VILLAGE OF HOFFMAN ESTATES
PLANNING AND ZONING COMMISSION
FINDING OF FACT

PROJECT NO.: 2014032P

PETITIONER(S): Adesa Inc.

PROJECT ADDRESS: 2785 Beverly Road

Figure 4:
Site Plan

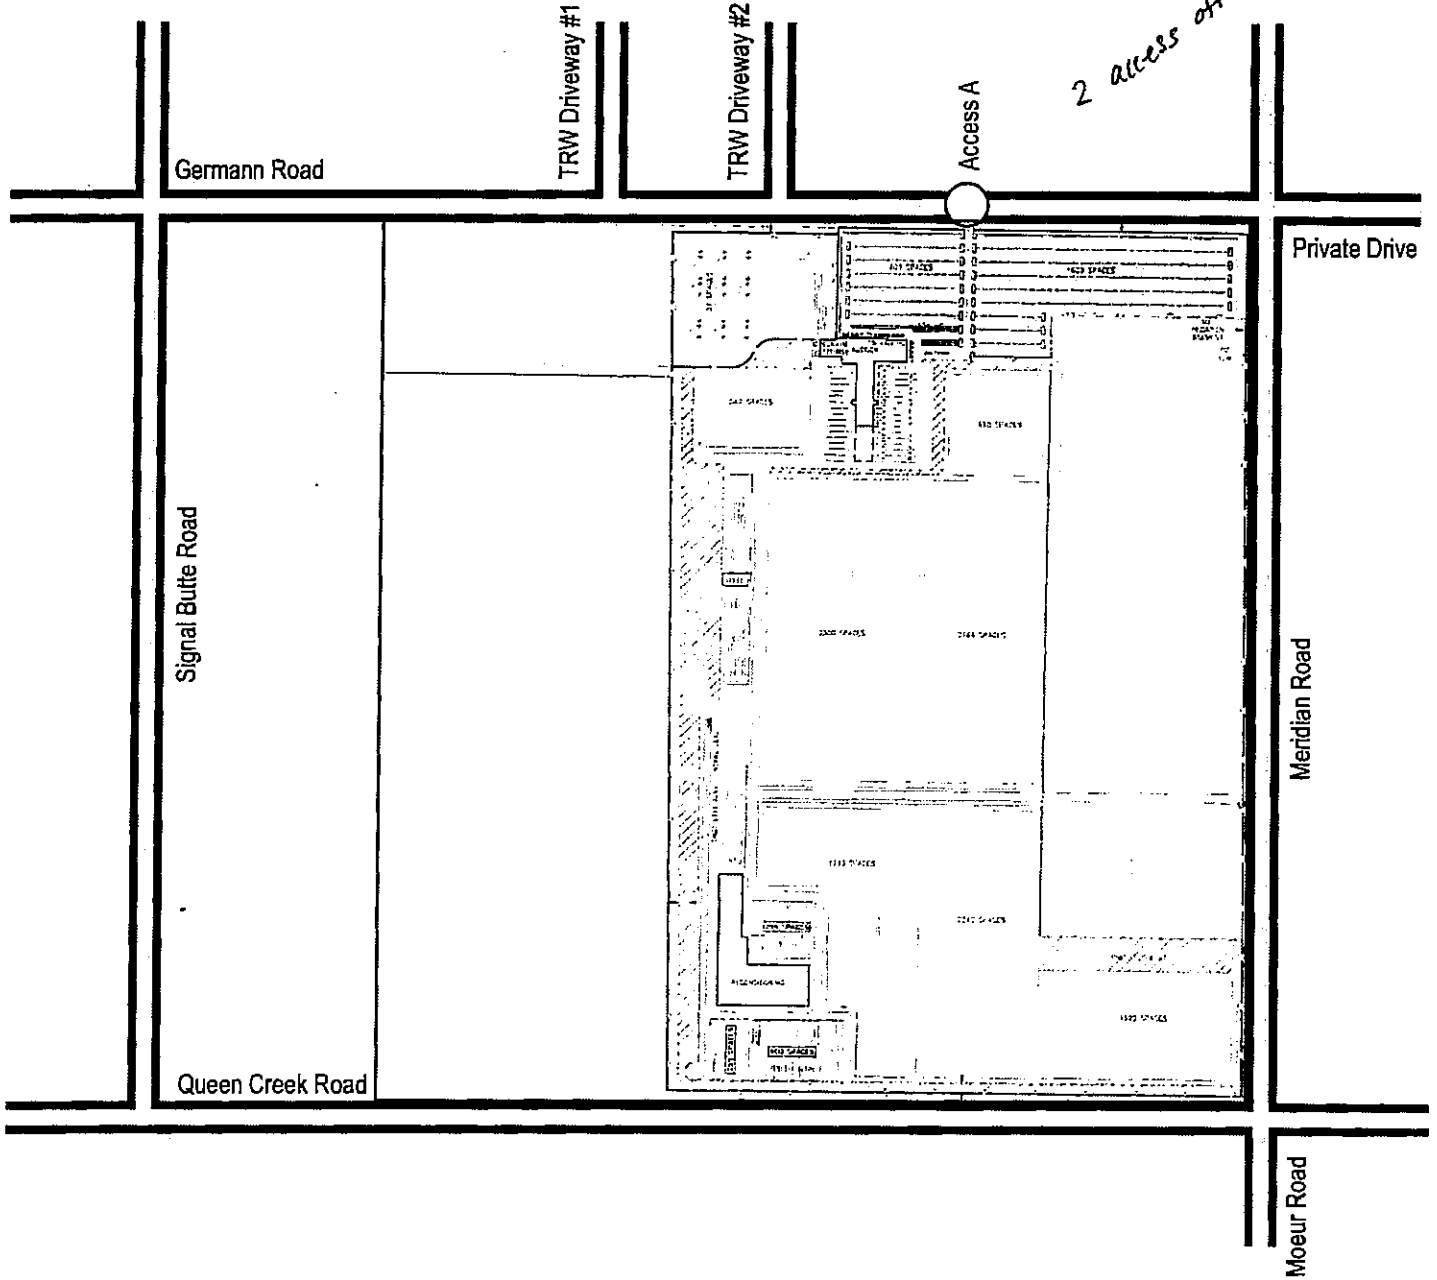
*Median on
Germann ?*

*125' Tower
2 access off Germann*
